Office Action Summary

10/516,486

MCGUIRE, JOHN

DETAILED ACTION

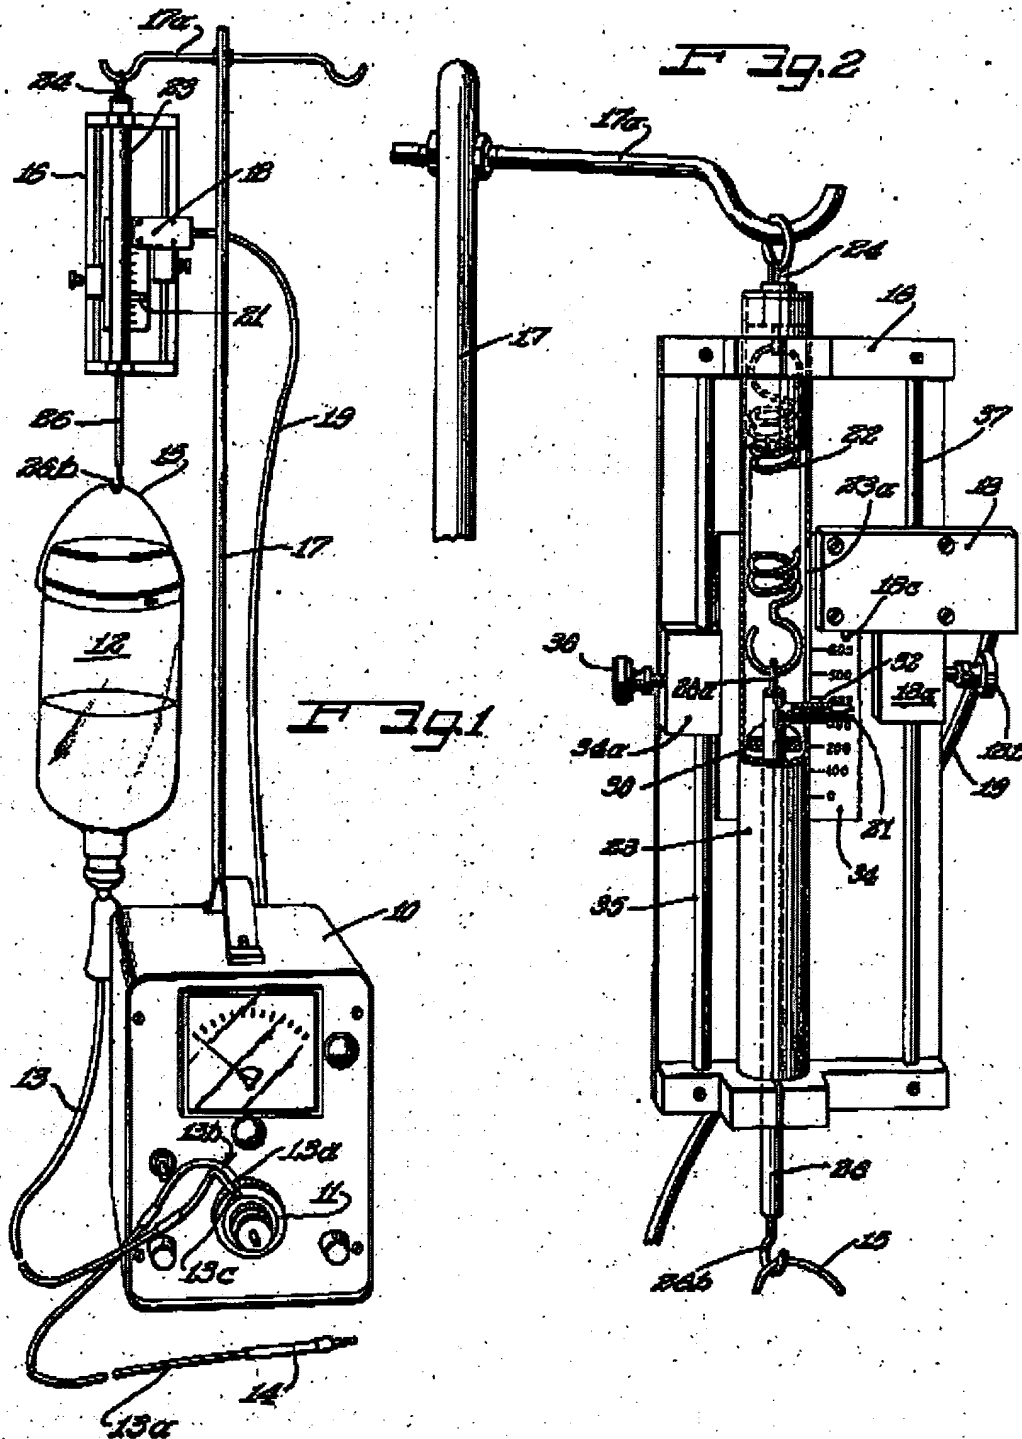
Claims 1,2,4, and 20 are rejected under 35 U.S.C. 102(b) as being anticipated by Gordon et al.(US003425415). Gordon teaches a controlled infusion system, referring to figures 1 and 2, comprising an indicator means(34), a first component with attachment means (26B) for a drip bag, that can move relative to a second component(17) in a substantially vertical direction, whereby movement of the first component activates the

indicator means, further comprising a third tubular (23) where the indicator means are on the third component.

Fig. 1

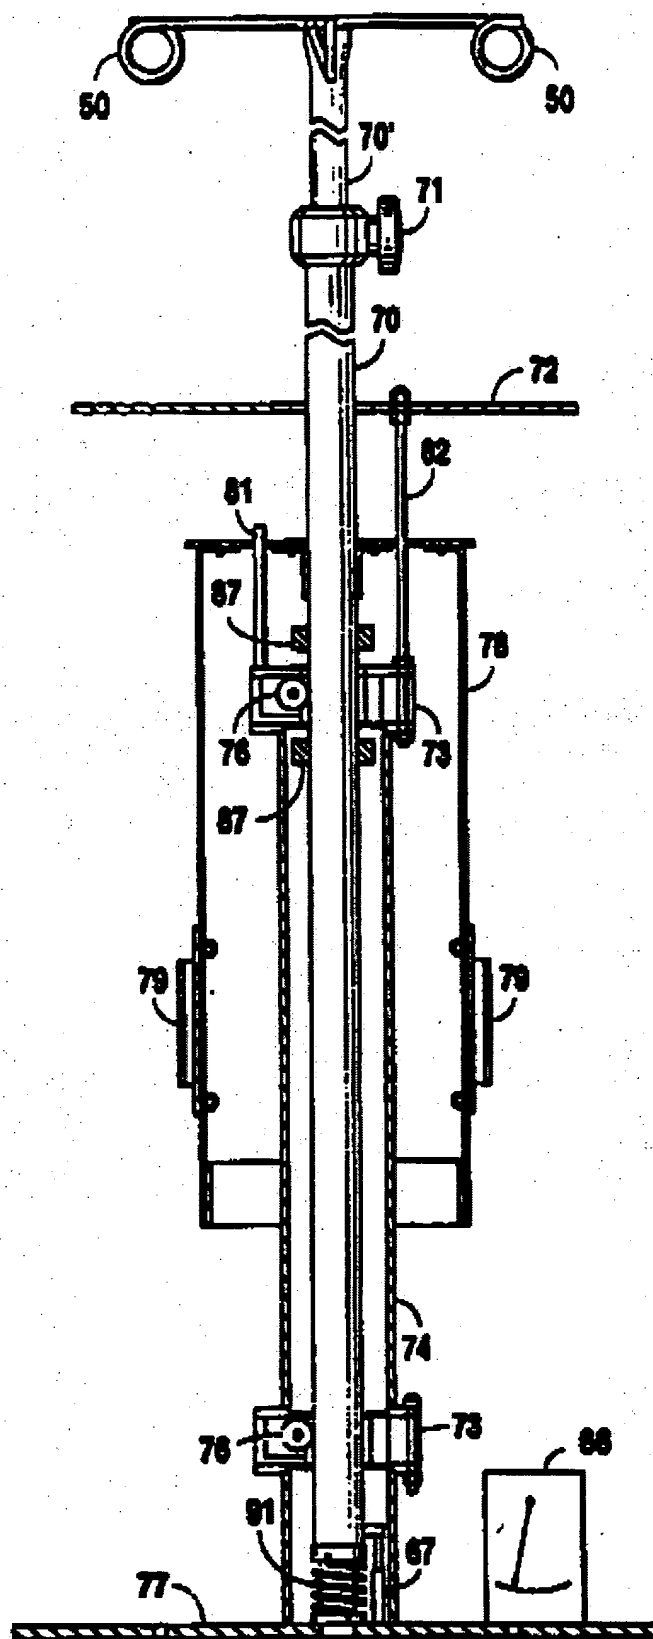
Claims 1,2,3,4,5,6,7,10,11, and 15 are rejected under 35 U.S.C. 102(b) as being anticipated by Vancaillie et. Al.(US005956130). Referring to figure 1, Vancaillie teaches a stand, comprising indicator means(67) a first component(70) with attachment means for a medical bag(50) and is adapted to move in a substantially vertical direction relative to a second component(74) where the movement of the first component activates the indicator means, the two components comprising hollow tubular sections, where the first component is positioned above and substantially within the top of the second section, where the lower region of the first section has a diameter smaller then that of the diameter of the uppermost section of the second component. The stand further comprising a compression spring(91) located in the second component where the first component makes contact with and sits on the compression spring. The indicator means mentioned above, in the embodiment of figure 1, comprise a means to measure the weight induced compression of the spring(91) whereby the means sends a signal to a computing means which activates either one or more of an indicator light or audible alarm, as detailed in the first paragraph of column 21 among other places, when the spring either compresses(weight added, i.e. medical bag filling) or extends(weight lost, i.e. medical bag emptying) past a predetermined point.

Fig. 4

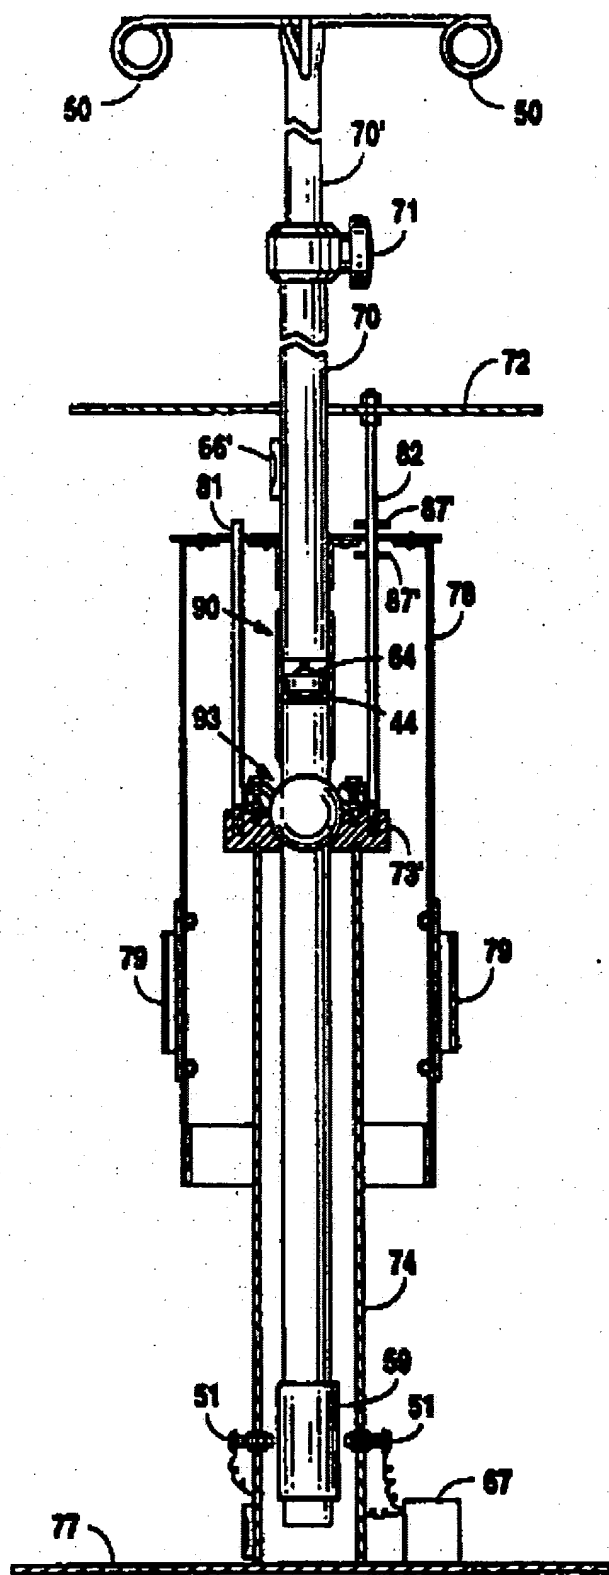
Claims 1,8 and 9 rejected under 35 U.S.C. 102(b) as being anticipated by Vancaillie. Vancaillie teaches another embodiment of a stand, as shown in figure 4, comprising an indicator means(here 64,51, and 67) where movement of a first component, taken as rod(70) upto load cell(64) including casing(78) and means to hold a medical bag(50), relative to a second component(74), whereby the lowermost region of the first component(78) is substantially over the uppermost region of the second component, where the diameter of the lowermost region of the first component is larger than the diameter of the uppermost region of the second component.

Fig. 81

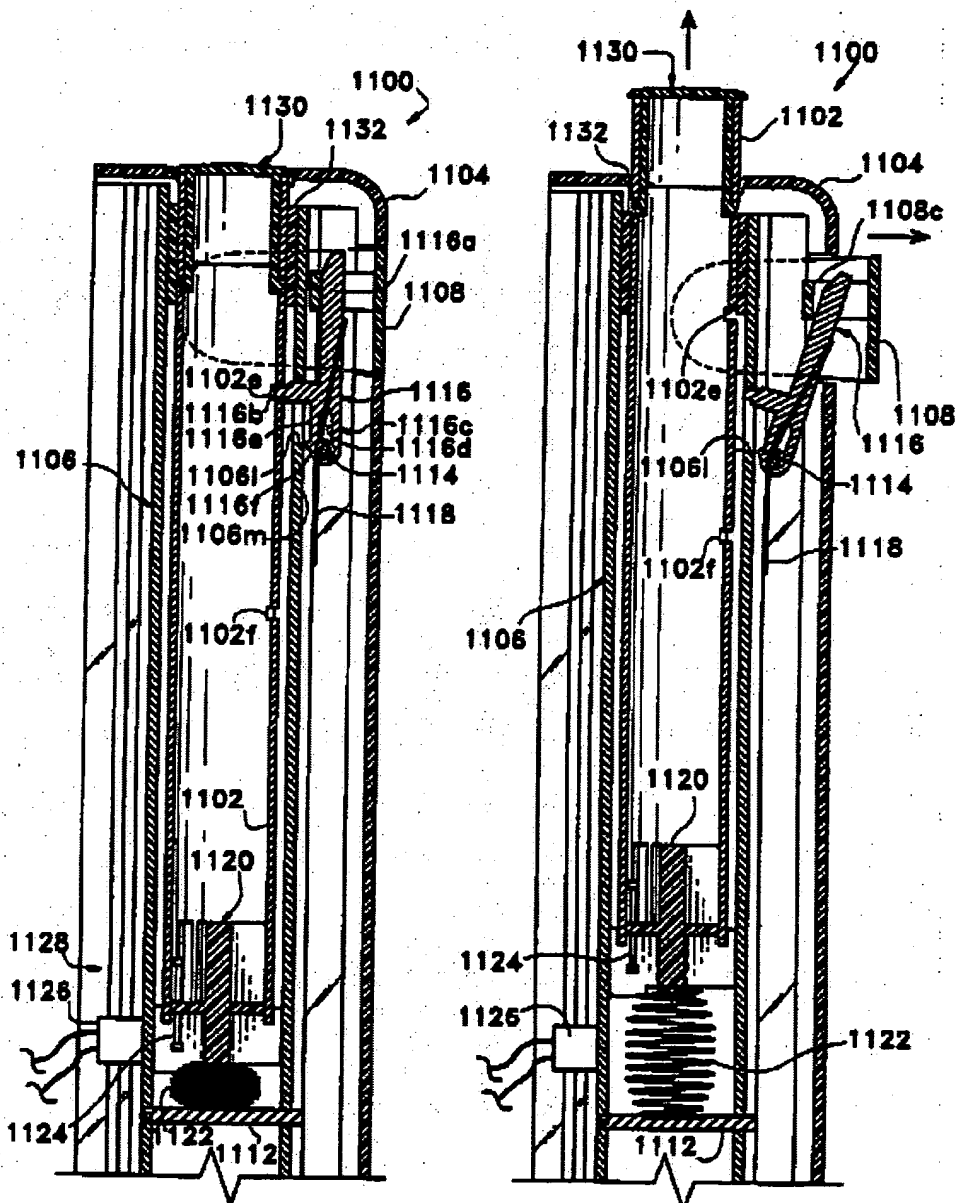
Claims 12,13,14,16,17,18 and 19 are rejected under 35 U.S.C. 103(a) as being unpatentable over Vancaillie as applied to claims 1 and 15 above, further in view of Ferrand et al.(US005906016) further in view of www.alliedelec.com, specific pages listed below. As detailed above Vancaillie teaches a stand with means to measure the relative motion of the first component to the second component, when either weight is added or subtracted to the first component, as well as teaching a means to select a predetermined point for maximum spring compression or expansion, where motion past this point would activate an alarm or indicator lights. The means of Vancaillie comprises a computing means, load cells, and a linear variable differential transformer to measure the compression of spring(91). However Vancaillie does not teach the use of a magnetic array and a reed switch as a part of the indicator means. Ferrand teaches a patient care

system comprising a telescoping rod assembly as shown in figures 81 and 82. The rod assembly is equipped with a magnetic array (1124) and a reed switch(1126) with the magnetic array on a first component(1102) and the reed switch on a second component(1106), and a spring (1122) on the second component with the first component resting thereon, where the magnetic array in proximity of the reed switch activates an alarm as detailed in paragraphs 141, 251 and 252 of the disclosure.

<http://www.alliedelec.com/Search/SearchResults.asp?N=0&Ntt=load+cell&Ntk=Primary&i=0&sid=455CFB807EC7617F>. Therefore it would have been obvious to one of ordinary skill in the art at the time of invention to replace the linear transducers and load cells of Vancaillie with reed switches and magnetic arrays as shown by Ferrand, in order to create a indicator system that would have the same basic functionality, in that indicator lights or an alarm could be activated by computing means when the magnetic array neared the reed switch as weight was either applied or taken off of the first

component, such as when a medical bag filled or empties respectively, because not only would this system provide the same basic functionality disclosed by Vancaillie it would be significantly less costly.
